COMMENTS AND RESPONSE REPORT

Bitou Municipality Land Use and Environmental Management via Email on Pre-App DBAR	
COMMENTS	RESPONSE
<p>It is requested that the proposed Nature Conservation Areas be formally declared as Protected Environment in terms Section 28 of the National Environmental Management: Protected Areas Act (NEM:PAA, Act 57 of 2003) to be able to give legal recognition of the sensitivity of the site. As such, Open Space Zone IV in the Bitou Zoning Scheme (2023) would be the appropriate zoning to apply for.</p>	<p>The environmental application stipulates that the remaining natural area is a No-Go area (irrespective of the final zoning) and it must be managed as a conservation area in any event.</p> <p>Apart from the already existing walkways/paths, pedestrian routes and dedicated vehicle routes for fire management and invasive alien management, the open space area must be managed by the applicant and in the future, the Managing Agent or Body Corporate / Homeowners Association of the proposed Plett Lagoon Estate.</p> <p>The long-term responsibilities of the applicant / HOA will be as follows (irrespective of the open space area being zoned Open Space III or IV):</p> <ul

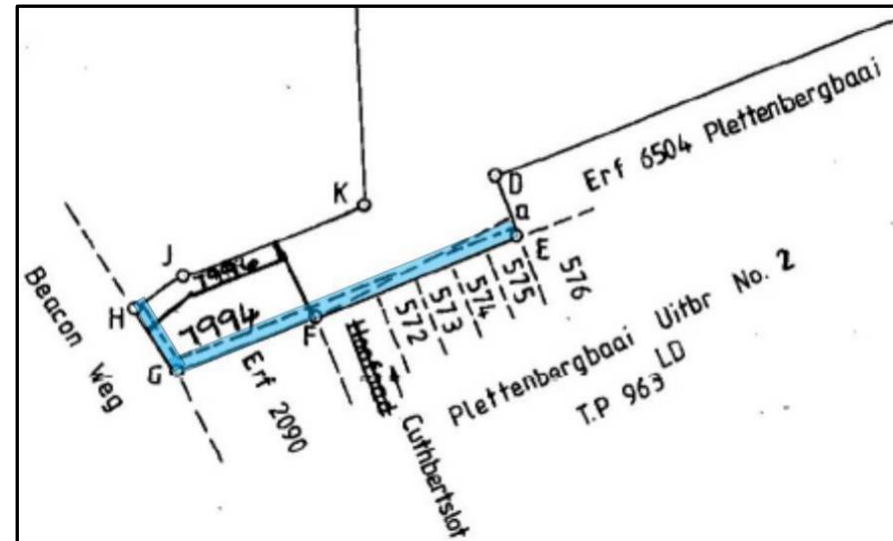
<p>this is only a conceptual plan and detailed building design has not commenced yet.</p>
<p>How can someone cancel a servitude if there is one behind my house. . And the pipes goes through my property. So that means the blue line is actually for municipality and us to use (Right of way) so know one can build there . I am scared off the clubhouse and the rubbish room will be at my house . If we can keep a the club house and rubbish building more to middle of the Property or to the otherside where the caravan park is. . It gives us still use for the back of thr property. 6 m is still on the servitude. Must be 15 m then if the servitude Burts they wound have a problem.</p>	<p>The servitude that was cancelled, was only a Right of Way Servitude registered on Erf 6503 to be used by Erf 6504 as an access only and had no relevance to any water pipelines or the Municipality for access to this water point. The cancelled Right of Way Servitude does not have an impact on the property boundaries of Erf 572, 573, 574 and 575 and was never intended to be used by Erf 572, 573, 574 and 575 as the Servitude was registered on the Title Deed of Erf 6503.</p> <p>I sent your images and concern regarding the water pipelines to the appointed Civil Engineer for review and comment. The Civil Engineer informed me that the water line is the connection for the current house on RE/6503. This line will not be used for the proposed development as the capacity is insufficient and therefore access to this valve will no longer be necessary if the development is completed.</p>

According to the appointed Urban and Environmental Planner, the servitude located on the southern boundary of Erf 6503 was registered as a Right of Way Servitude to be used by Erf 6504 as an access only. I marked the servitude in Blue in the image below.

This servitude was cancelled, and Erf 6504 now obtains access directly from Susan Street. From what we can gather from the information in the Title Deed and Planning Report, this servitude was only registered in favour of Erf 6504 and does not have an impact on the property boundaries of Erf 572, 573, 574 and 575.

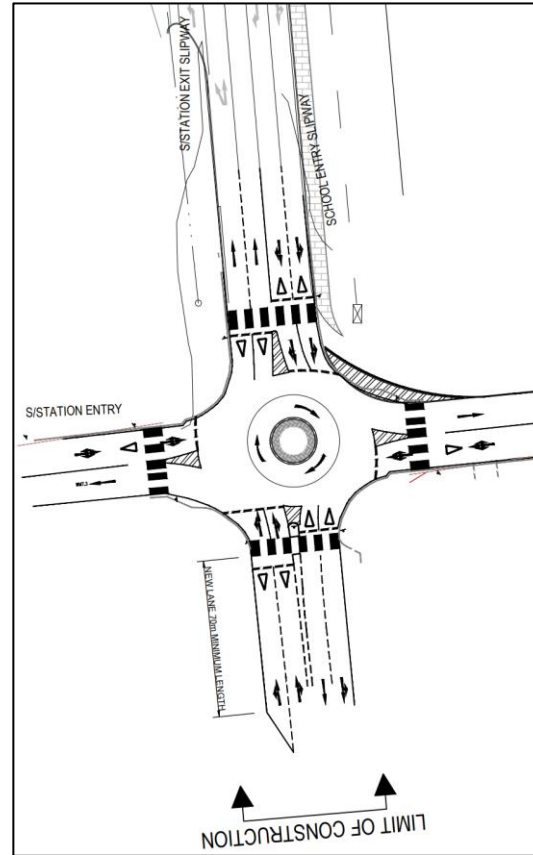
<p>agree to mutually accepted terms pertaining to construction vehicular movement along the school access road leading up to the intended development (“the Development”).</p>	
<p>Whilst we are in principle not opposed to access to the Development being obtained via a traffic circle at the proposed intersection and via the School Access Road, we wish to highlight the following concerns which need to be addressed by the applicant:</p> <p>1. The Traffic Circle in its current proposed format is noticeably not large enough and is not applicably designed to accommodate large truck movement. Whilst there is a concern for the safety of road users in general, this particularly presents a serious concern to Shoprite as convenient and safe truck maneuverability at the intersection in question is vital to the success of our Checkers supermarket’s delivery operations. Shoprite cannot support any traffic circle design that does not take the natural movement of our delivery trucks into account. We submit that the design of the Traffic Circle be revisited to accommodate our delivery truck movement and be presented to Shoprite for further comments therein.</p> <p>2. The above concern is corroborated by the applicant’s own traffic engineers who uphold that the proposed size of the Traffic Circle is considered undesirable as sufficient deviation is not provided for through traffic. The traffic engineers further maintain that the wheel-tracking for trucks making a right-turn movement would encroach on the left-turn lane of the same approach and</p>	<p>The traffic circle design was discussed with Bitou Municipality, the Civil Engineer, Traffic Engineer and developer during a meeting on 22 October 2024. The Bitou Municipality noted that the design of the traffic circle which they approved on 14 February 2024, is the standard size used for traffic roundabouts in the Bitou Municipal District. The traffic circle design allows for mountable curbs on the circle centre “island” which will allow large trucks to safely drive around the traffic circle. Bitou Municipality noted that this is the prescribed standard design due to spatial constraints and that the traffic circle currently under construction at the N2 – Beacon Way intersection is of a similar standard with large trucks driving over the mountable curbs.</p> <p>The slipway entry currently under construction from Beacon Way to the Plettenberg Bay Primary School entrance will allow large trucks to easily turn into the school road from Beacon Way and therefore alleviating traffic towards the school entrance.</p> <p>Wheel tracking for the proposed traffic circle design was simulated using an 18.2m single carriage truck.</p>

cut into both circulating lanes, which is undesirable. The engineering reports and traffic impact statement ("TIS") refer to truck tracking, but this is not indicated on any plans in said reports. It is also not clear on which truck size the applicant's engineers based their tracking modules on. It is essential that this information be revealed.

Based on further discussions held with Bitou Municipality, it is suggested by the Traffic Engineer that **a traffic signal** at this intersection be considered as an alternative. The provision of traffic signals **would not require additional road widening at the intersection**, and would have **a lesser impact on the existing operations** of the Checkers Centrum / Filling Station delivery vehicles at/through the intersection. Traffic signals at this intersection can be expected to result in acceptable services levels along all approaches to the intersection. As a result of the available intersection spacing along Beacon Way, the said analyses were done taking into consideration the proximity of the
